APPLICATION FOR PERMIT
TYPE I MUNICIPAL SOLID WASTE FACILITY
MSW PERMIT NO. 2374
PESCADITO ENVIRONMENTAL
RESOURCE CENTER
RANCHO VIEJO WASTE MANAGEMENT, LLC
SOLID WASTE DISPOSAL FACILITY
LAREDO, WEBB COUNTY, TEXAS

September 15, 2011

**Reference: Pescadito Environmental Resource Center – Webb County
Municipal Solid Waste (MSW) – Proposed Permit No. 2374
Response to First Notice of Deficiency (NOD)
Tracking No. 14710139; CN603835489/RN106119639**

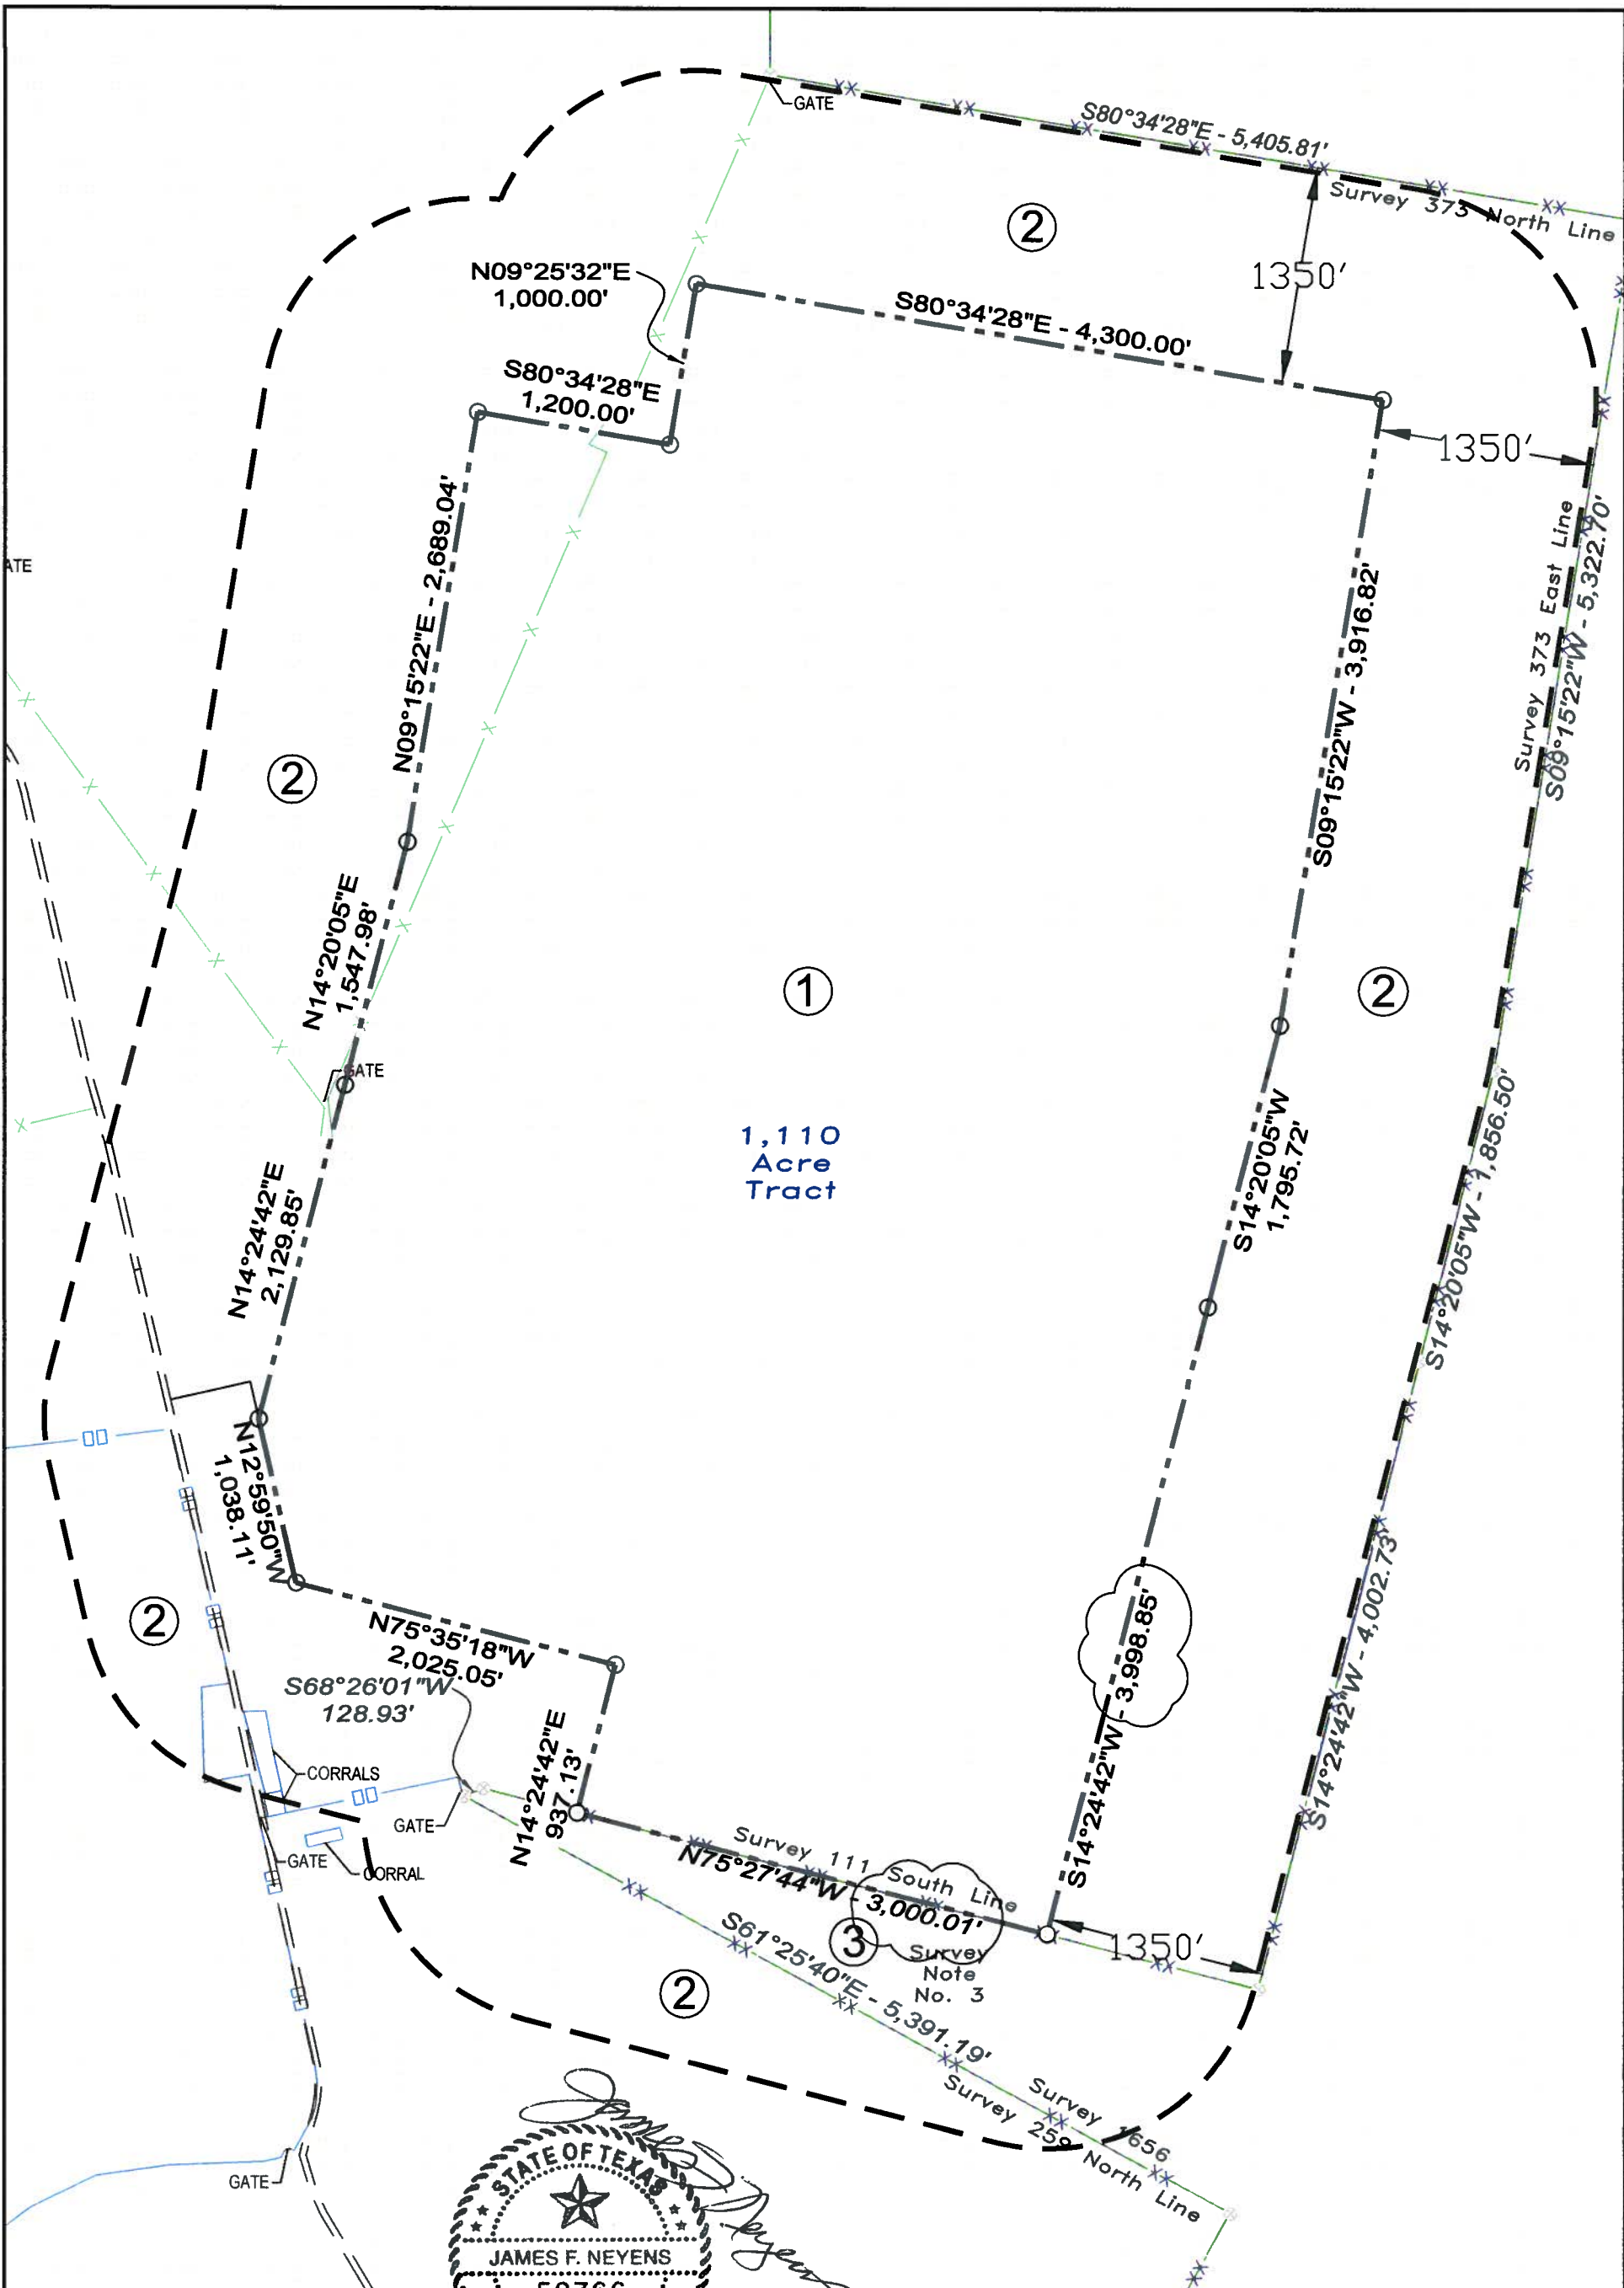
13. *The Land Ownership Map (Figure 3, Part I). Please identify easement locations on the Land Ownership Map.*

Easement locations were determined by Mejia Engineering Company (MEC) and are shown on Part I, Figure 4. Figure 4 consists of Sheet 1 of 2 and 2 of 2, and these have been signed and sealed by a MEC registered professional surveyor. Because MEC prepared, signed and sealed the easement information, not TRC, we believe it is appropriate to show these easements on the signed and sealed MEC drawings rather than on a drawing signed and sealed by a TRC engineer. We also believe this approach shows the easements with greater clarity.

FIGURE 4

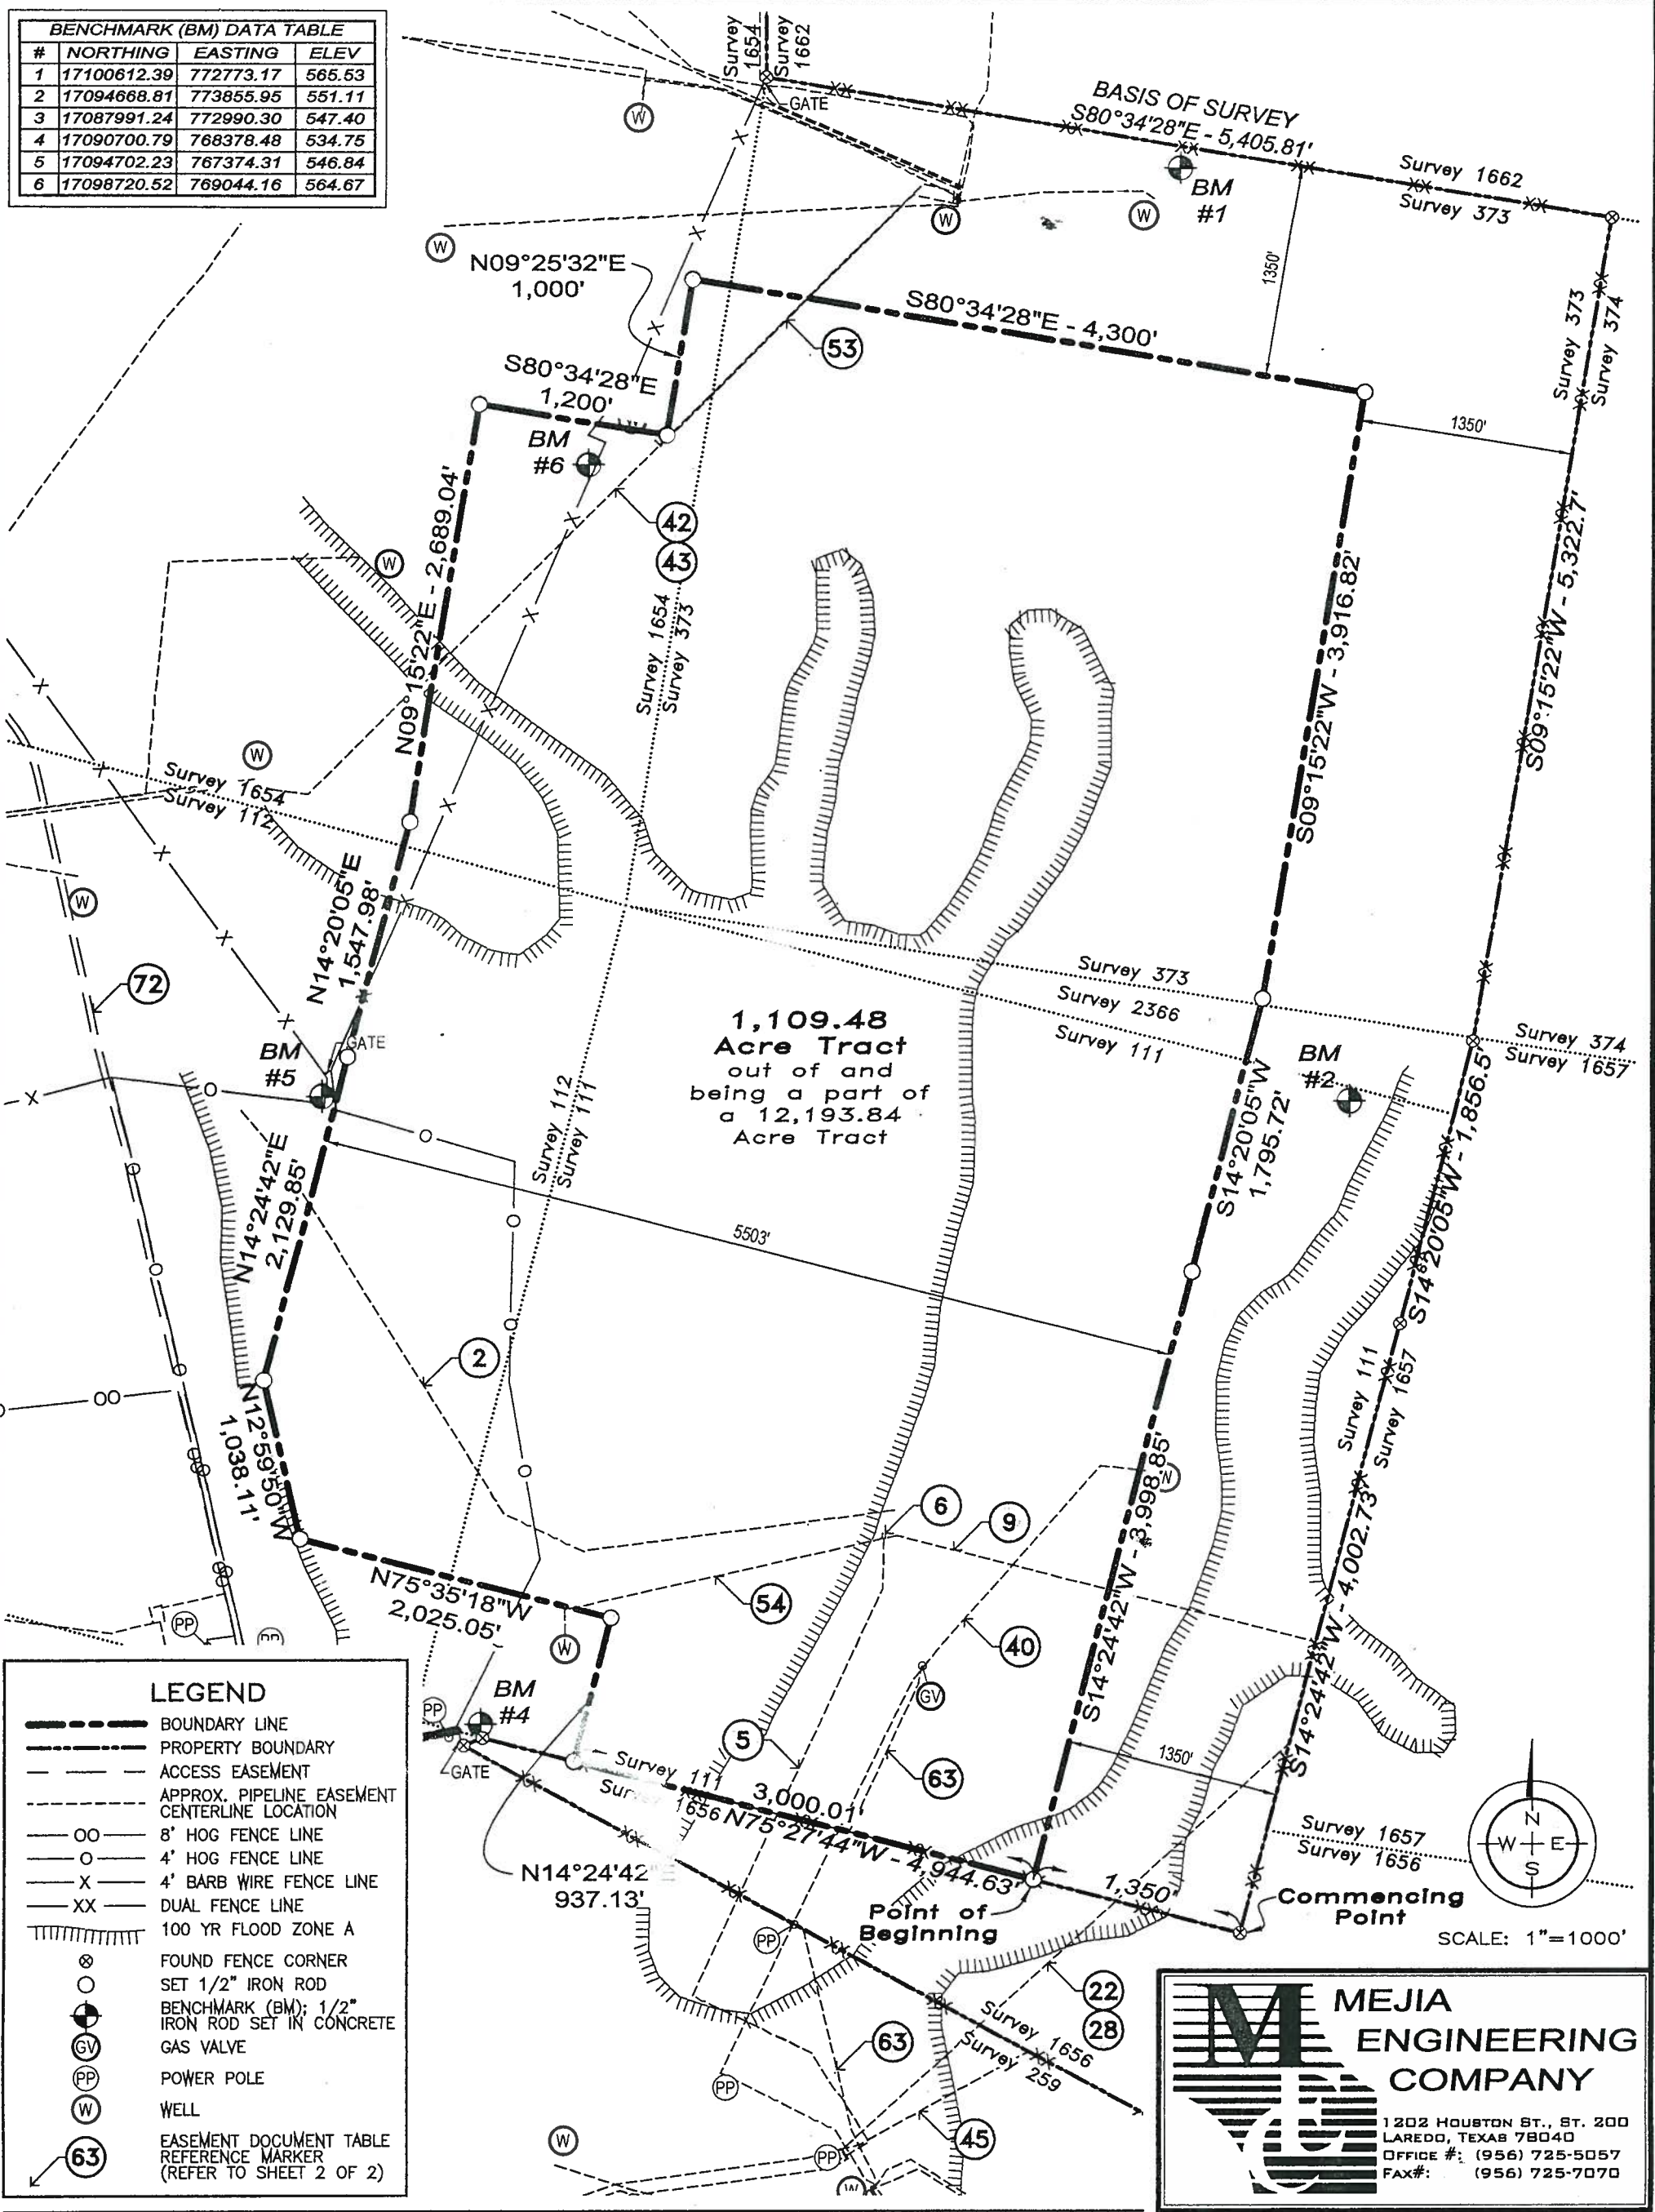
30. *General Location Maps, Section 3.0.* For drainage, pipeline, and utility easements within or adjacent to the facility, paragraph ten of this section refers to Application Part I, Figure 4. However, Figure 4 is not identified in the Figures section of Application Part I. Please correct this discrepancy. (30 TAC §330.61(c)(10)).

Figure 4, Sheets 1 of 2 and 2 of 2, is now identified in the Figures section of Application Part I. This figure shows the only known easements on or adjacent to the facility, all of which are for either pipelines or access rights-of-way to facilitate oil and gas production. These easements are subject to revision when they are no longer needed for their intended purpose. As gas production plays out, these easements will be removed as the pipelines and access roads are no longer needed.
